**ADDENDUM
NO. 4**

October 18, 2024

**Whiteland High School Ph 2: Café Kitchen Band Choir Auditorium
300 E. Main Street
Whiteland, IN 46184**

ROOF DETAILS

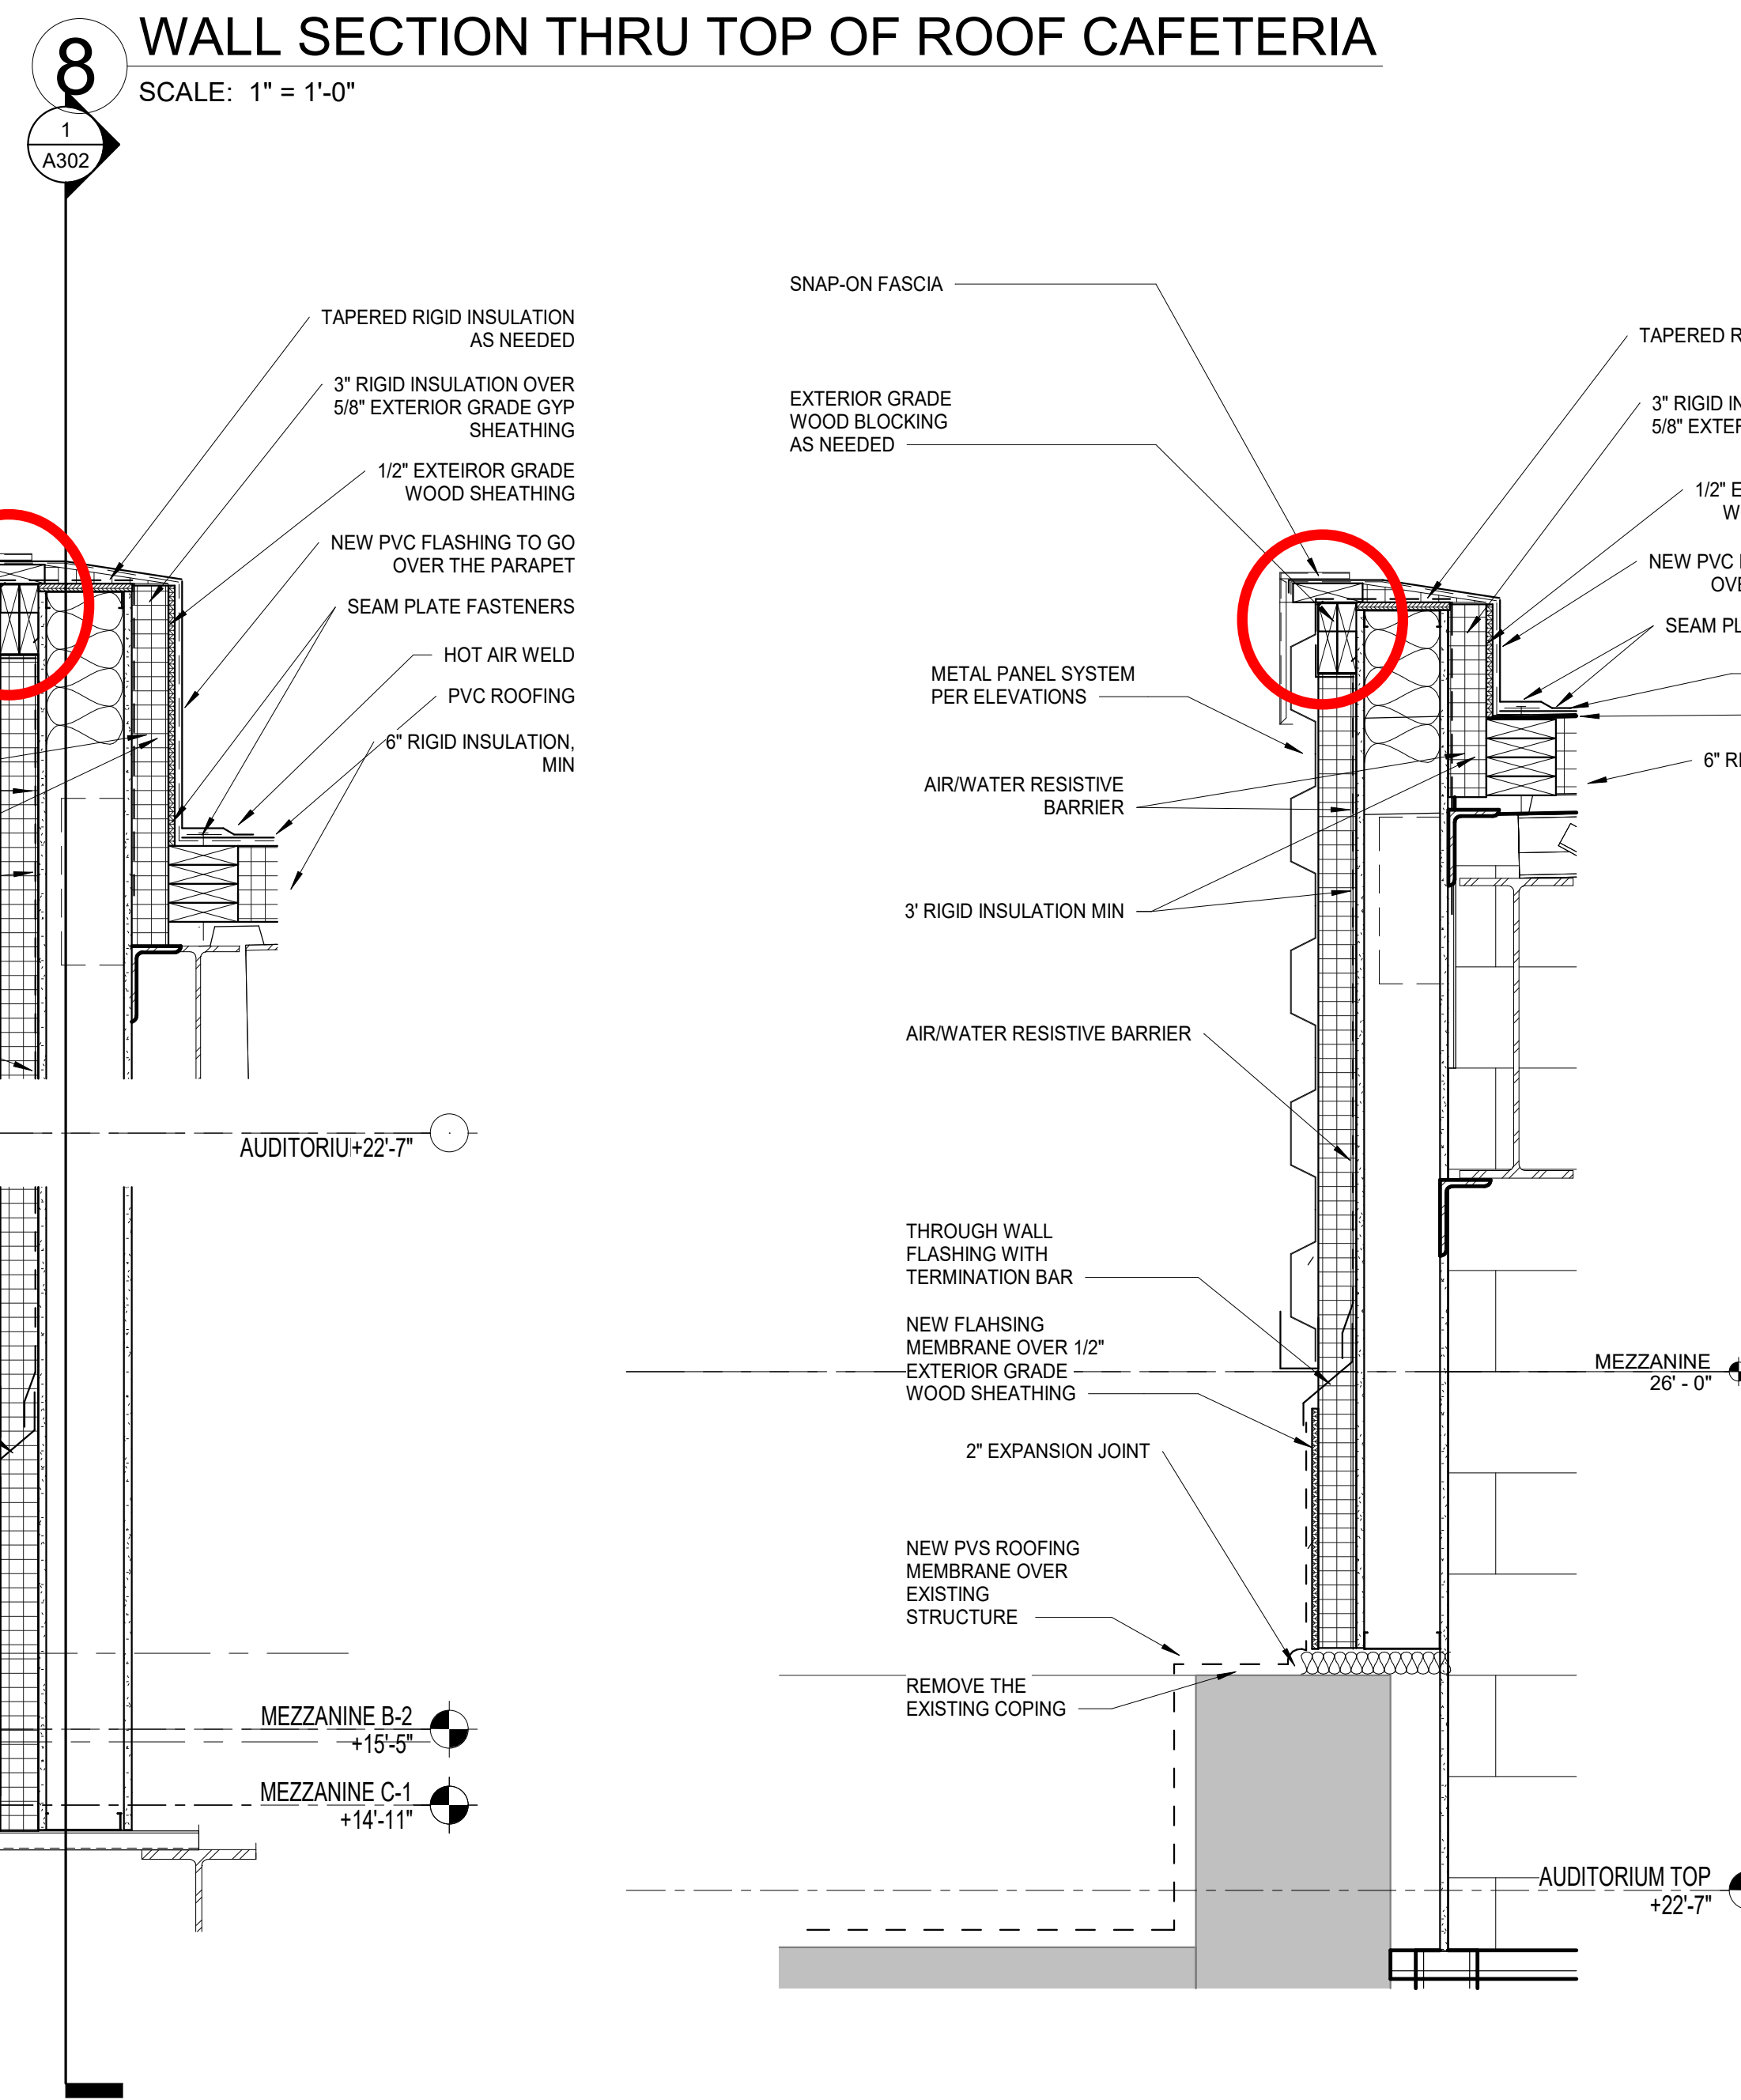
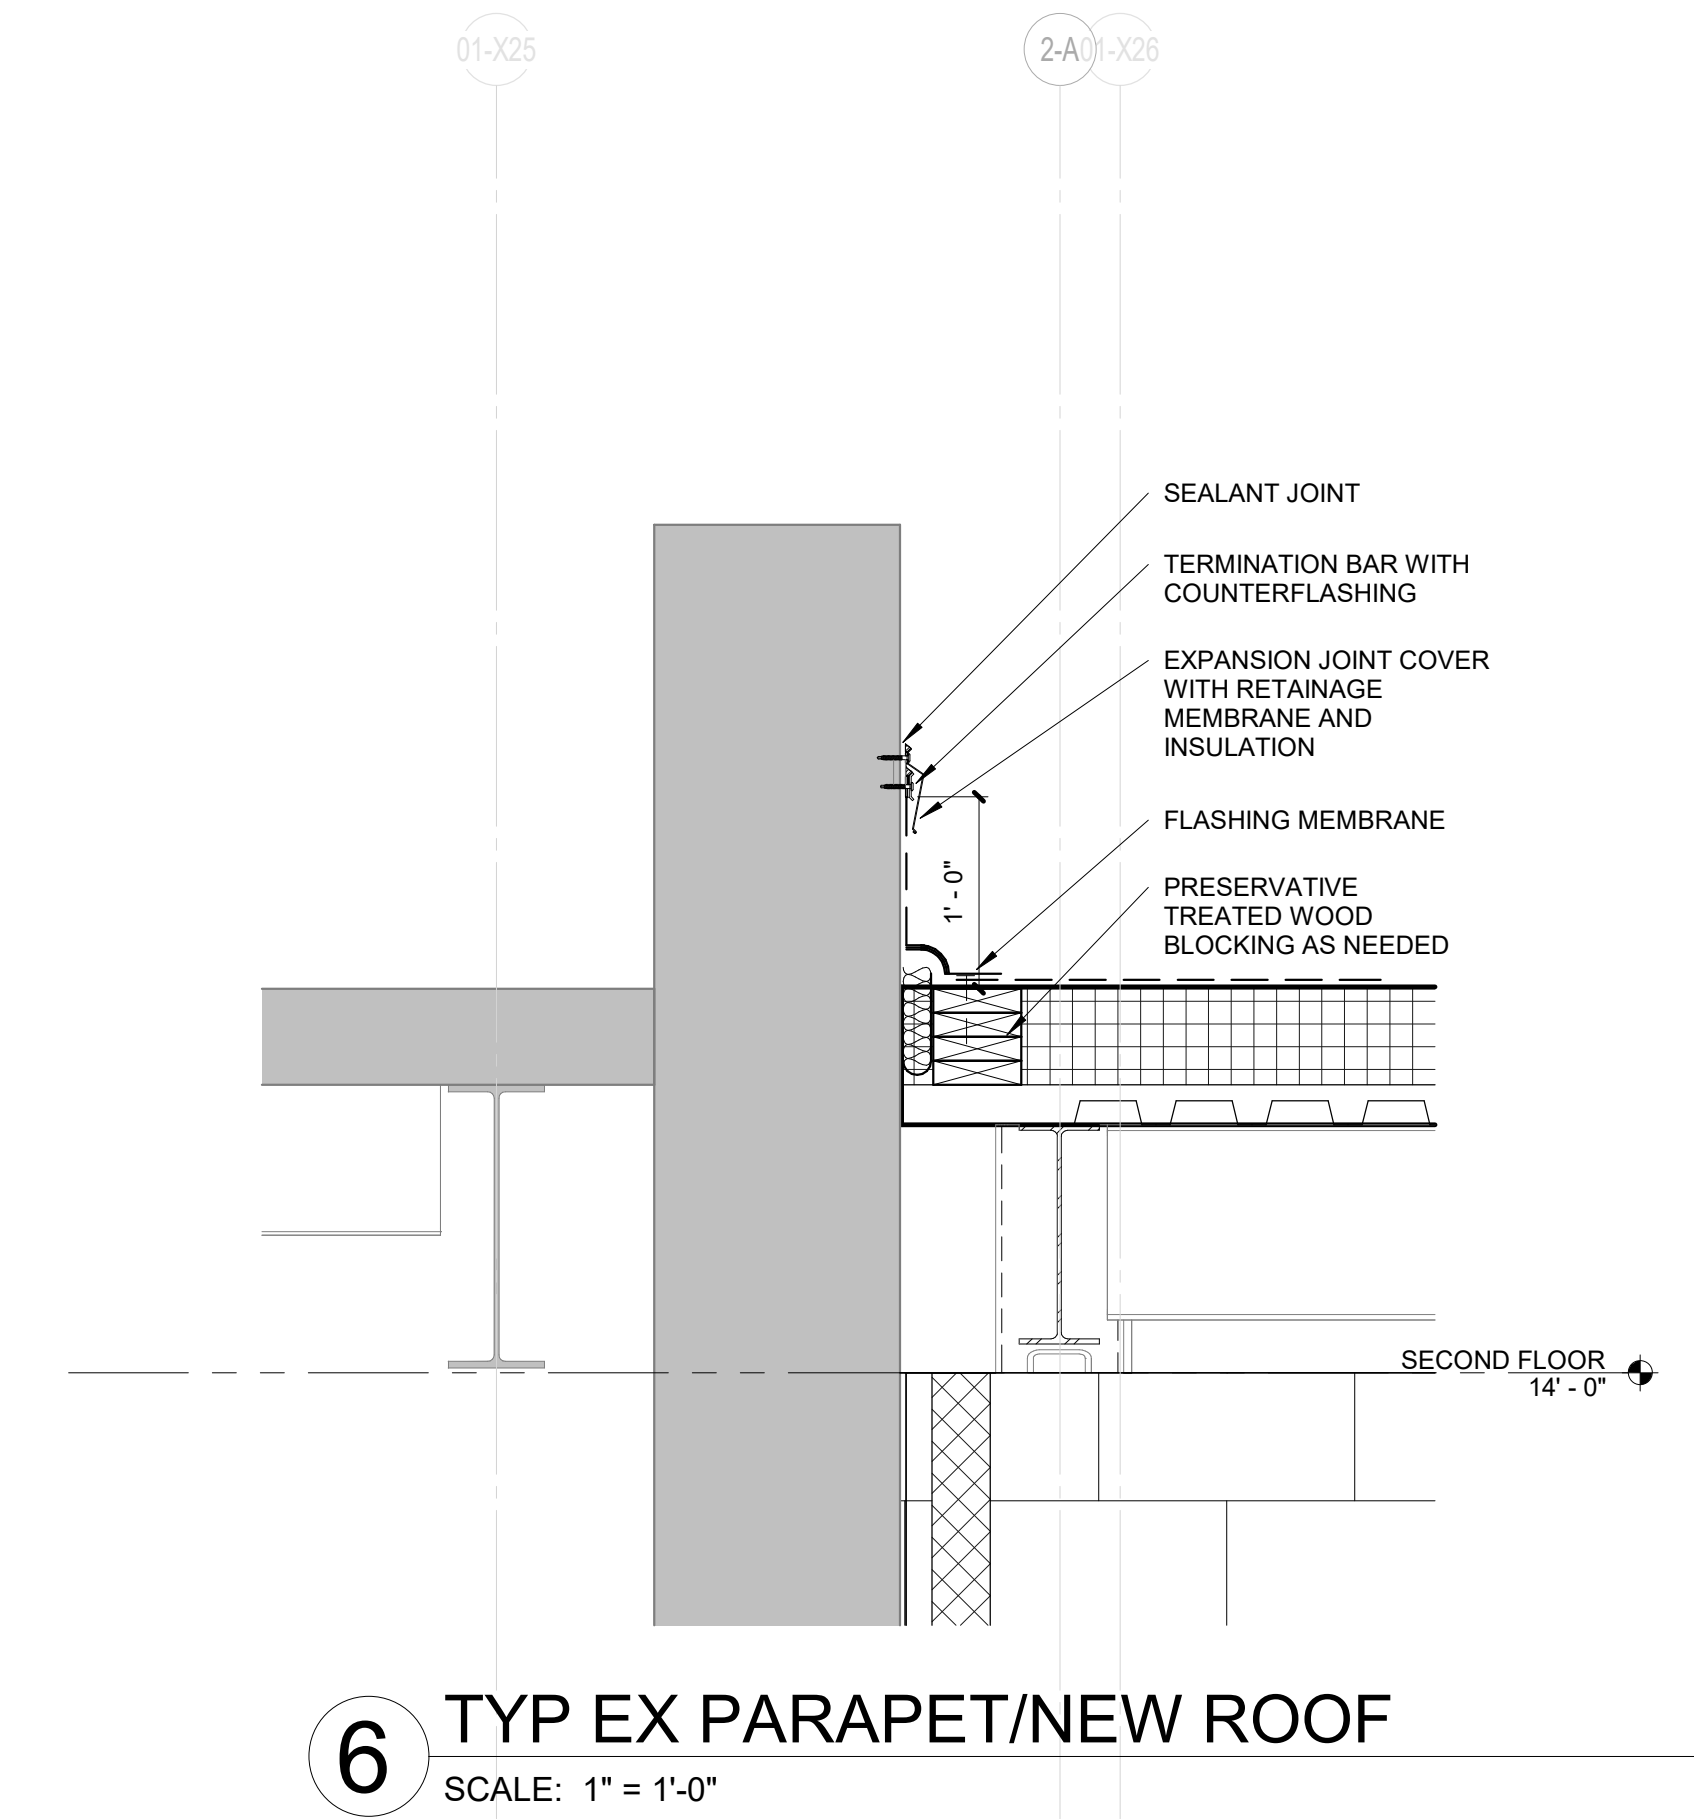
7. Bid Category No. 5 – Metal Studs, Drywall, and Acoustical Contractor is responsible for any board insulation behind metal panels that include Z-Girt installation.
8. Bid Category No. 5 – Metal Studs, Drywall, and Acoustical Contractor is responsible to provide and install all required wood blocking circled in red in the attached

all blocking in question and circled in red will be the responsibility of Bid Category No. 5 Contractor
